RE: **P.Z. 06-2020 15310 Conway Road (SMS Group)**: A request to repeal and replace Ordinance 2463 to establish a new “PC” Planned Commercial District to modify development criteria for a tract of land totaling 1.492 acres located at the southwest corner of the intersection of Chesterfield Parkway East and Conway Road (18S310557).

Planning Commission Staff Report

RE: Responses to Planning Commission Comments - 15310 Conway Rd

PRELIMINARY PLAN

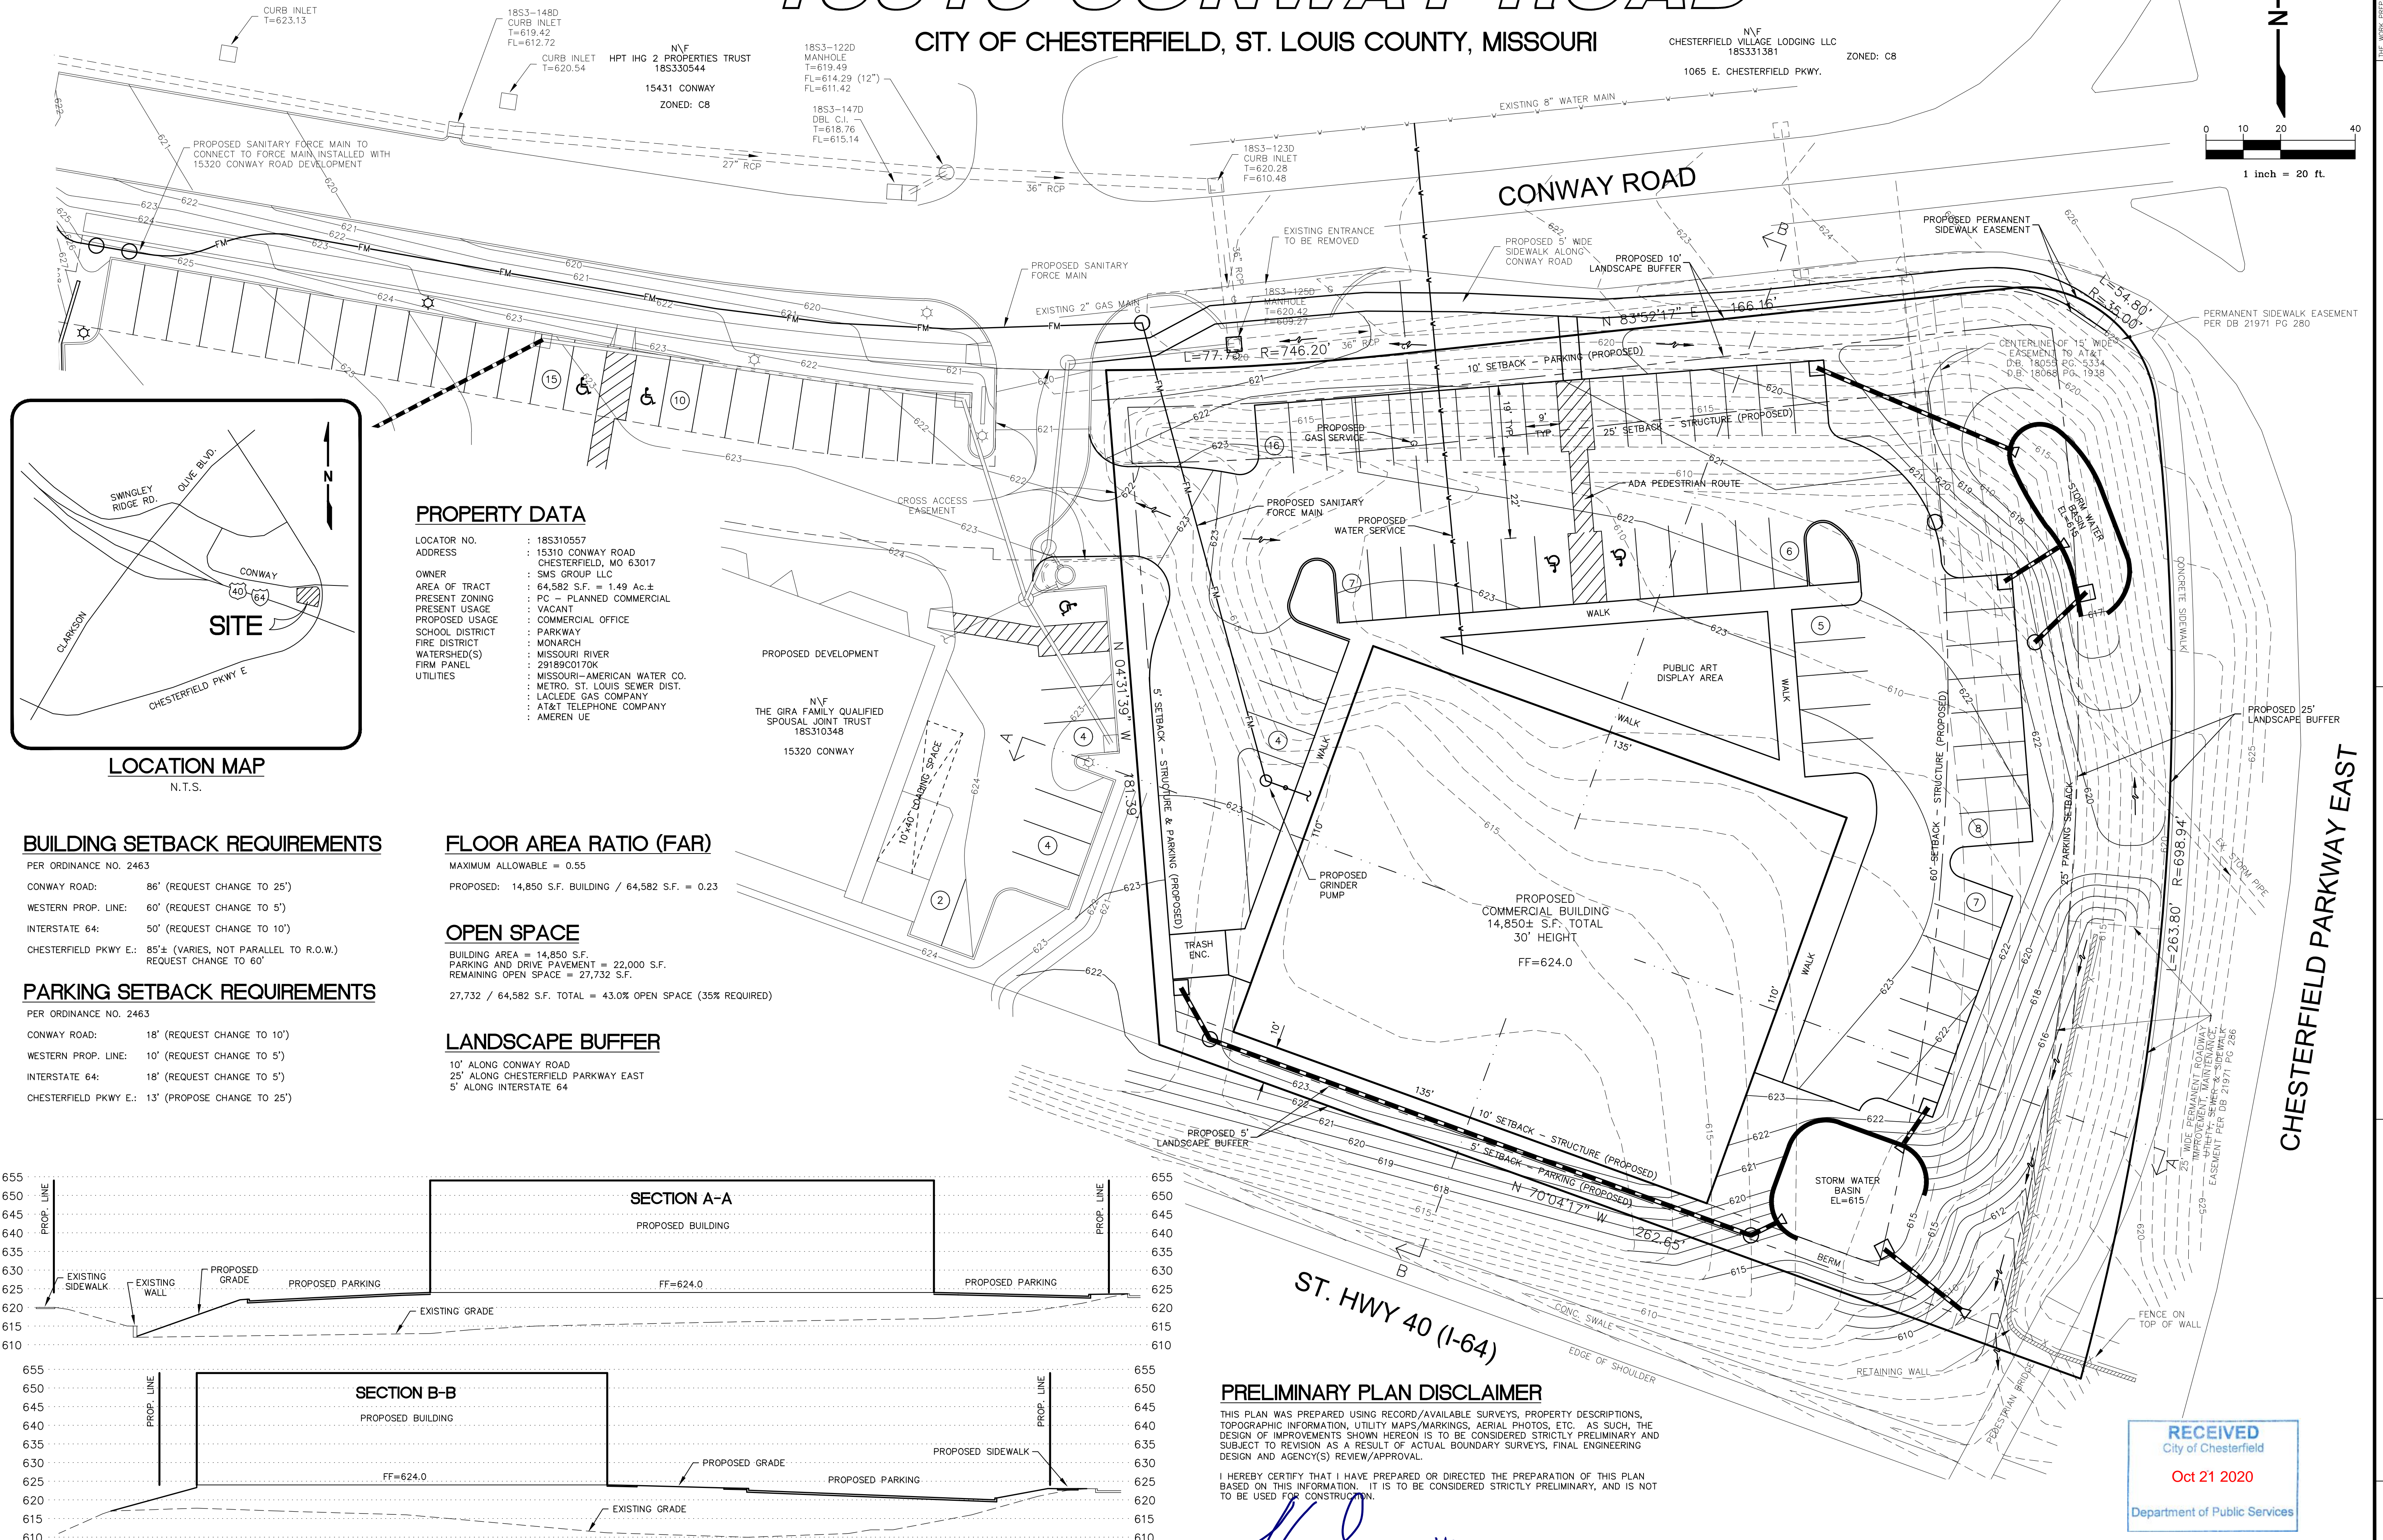
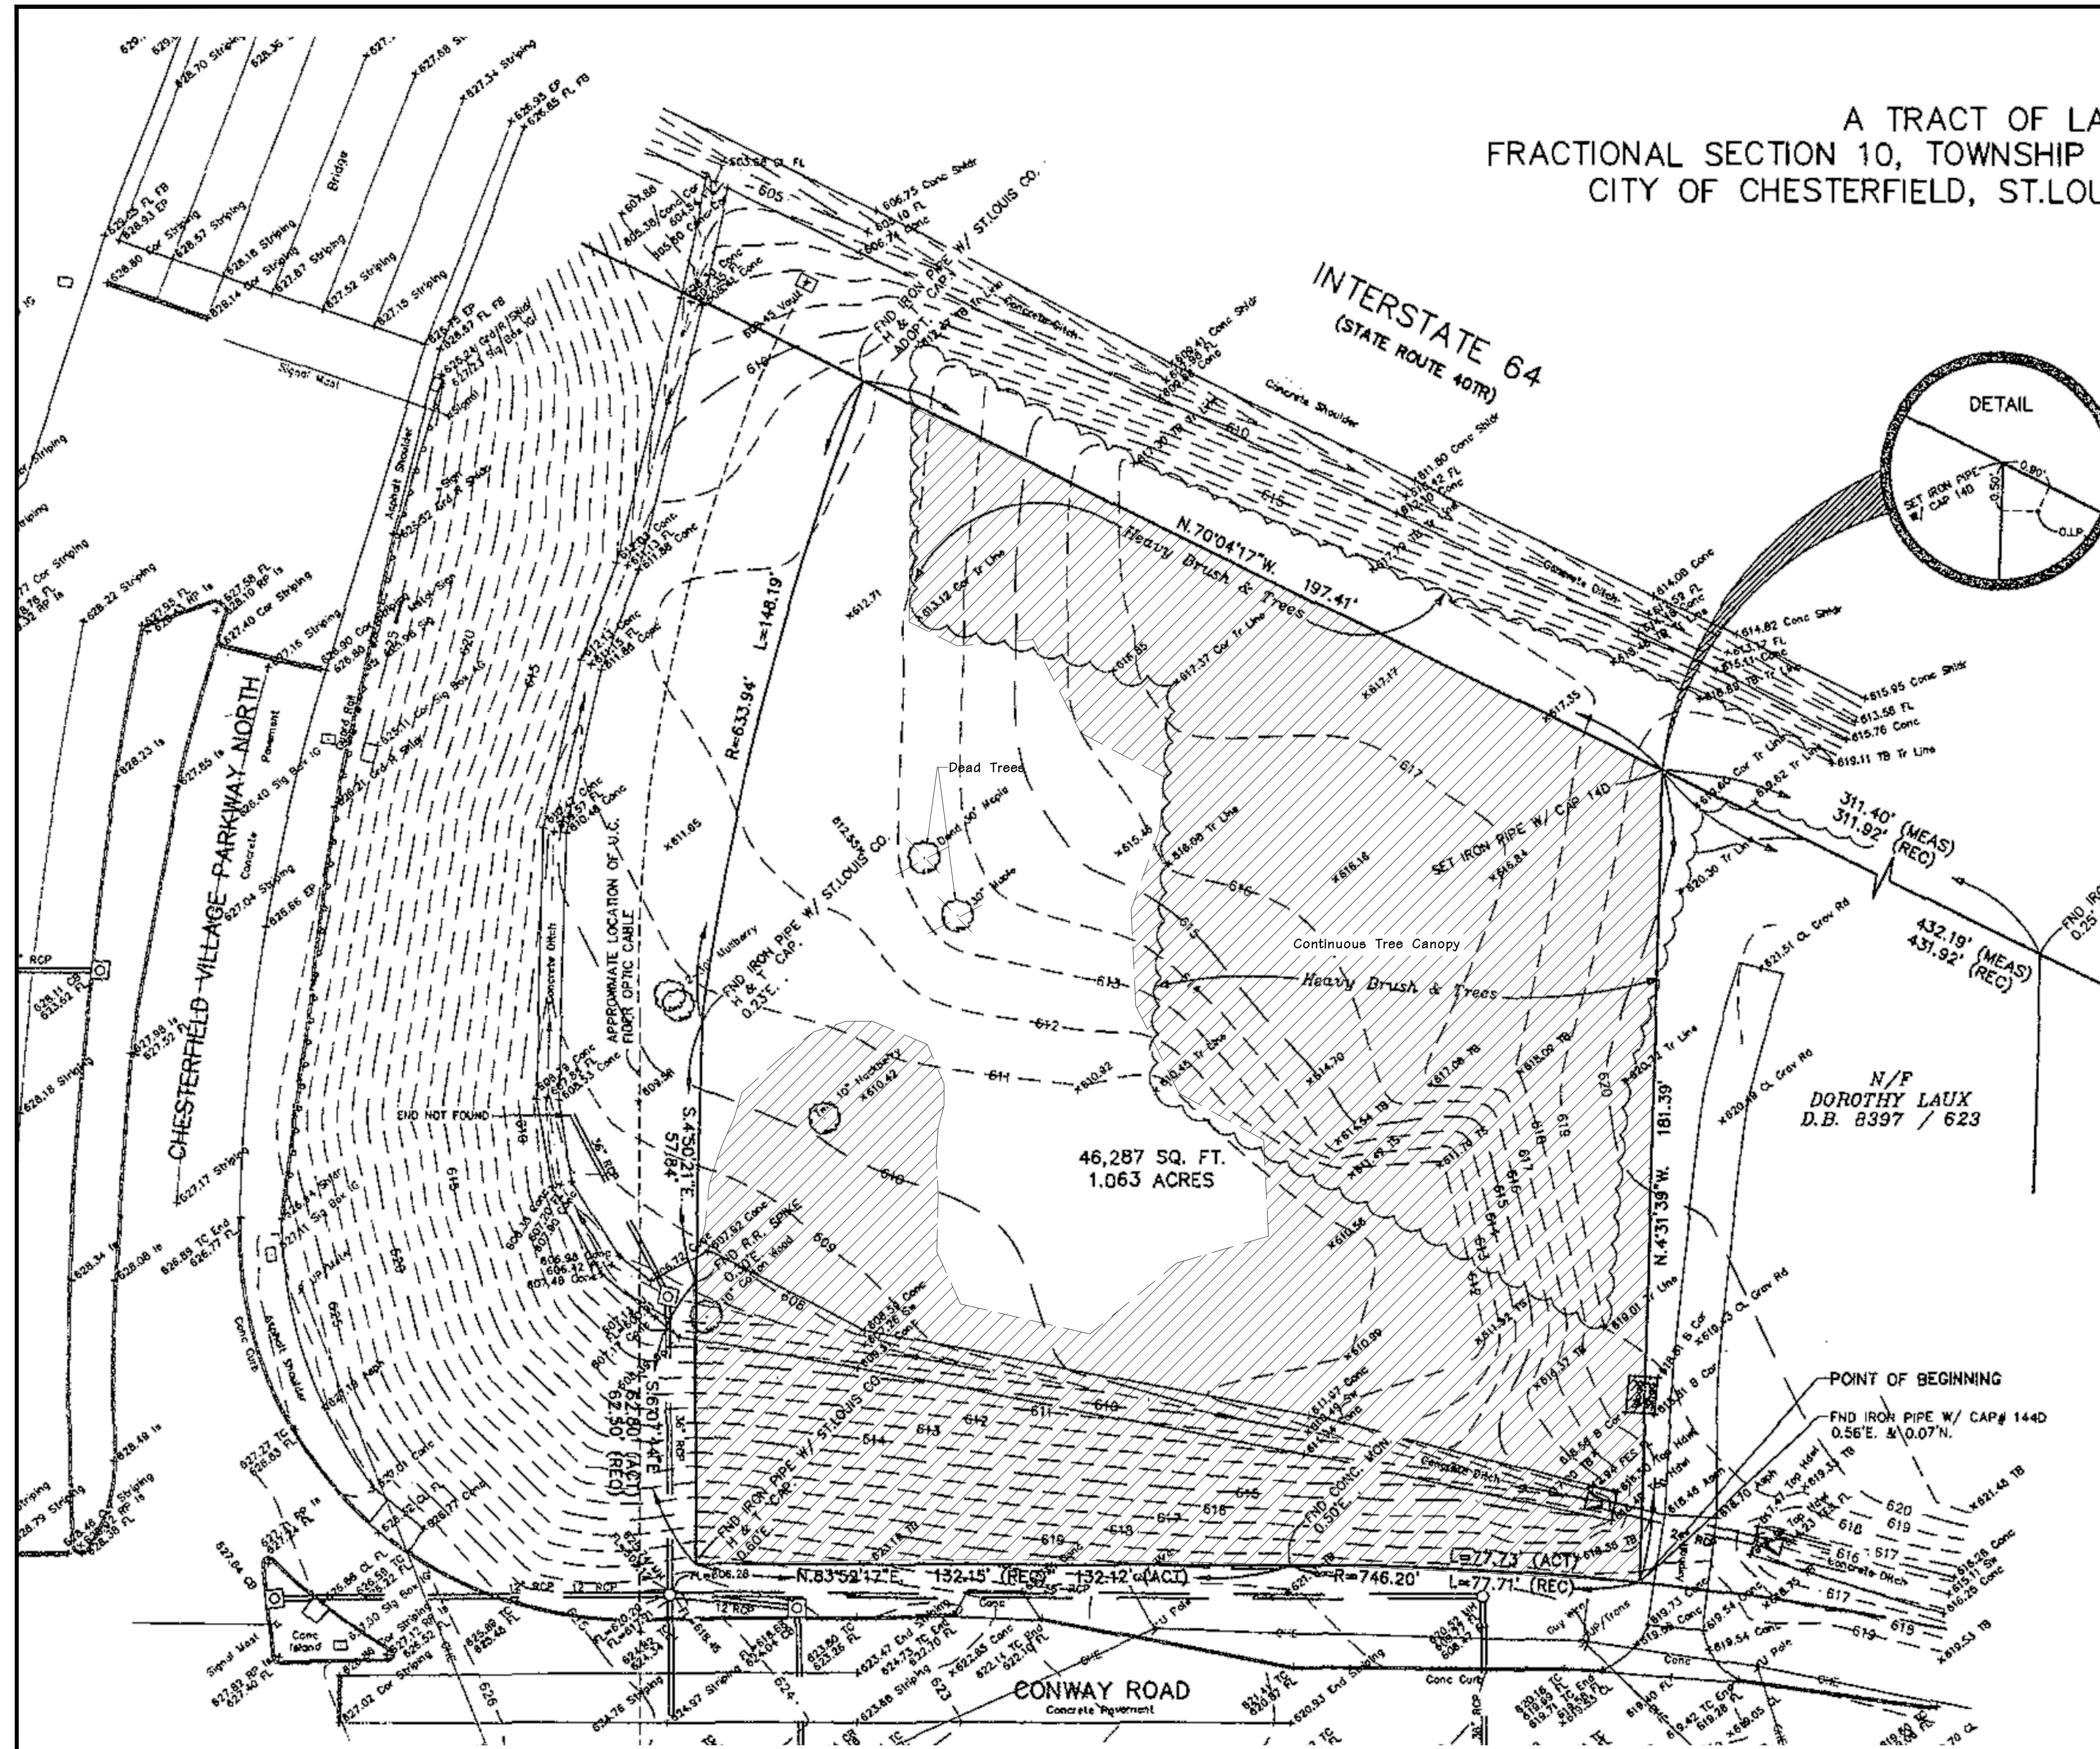
- **Issue:** Setbacks—Planning Commission expressed their concern that the proposed parking setbacks along Conway Road do not reflect those for the hotel development across the street.

- **Issue:** Landscape Buffers—Because of the high visibility of the site from Chesterfield Parkway, Planning Commission noted that landscaping must be closely reviewed and expressed concern about the reduction of Landscape Buffers to match parking setbacks.

Response: The applicant has made changes to the proposed setbacks relating to the northern and eastern boundaries along Conway Rd. and Chesterfield Parkway, respectively. The plan now reflects a northern boundary parking setback extended from five feet (5’) to ten feet (10’) to match that of the hotel development across the street. The eastern boundary parking setback has also been extended from the previous request of thirteen feet (13’) to twenty-five feet (25’). These figures are updated in the parking setback table below:

Response: By doubling the parking setbacks along Conway and Chesterfield Parkway, the applicant has increased the area of Landscape Buffer to the same depths of 10’ along Conway Rd. and 25’ along Chesterfield Parkway. Figure 4 shows the revised Landscape Buffers that align with parking setbacks in and around the subject site.

- a. We have made changes to our proposed setbacks relating to the northern (Conway RD) and eastern (Chesterfield Parkway) boundaries. We have revised our plan and request to reflect a Northern Boundary setback at 10' for both parking and landscape allowing a 5' greater buffer than that of 15320 Conway Rd (adjoining to the west). We also adjusted the Eastern Boundary parking and landscape setbacks from the current 13' to 25' allowing for a greater buffer along Chesterfield Parkway. This is reflected on the project narrative and current site plan.

- a. Per section 1 above, we have proposed an increase to the landscape buffer. Additionally we will take great care in devising a plan that is aesthetically pleasing at the intersection of Conway Rd and Chesterfield Parkway. These plans will be presented for review once our landscape plan has been completed.
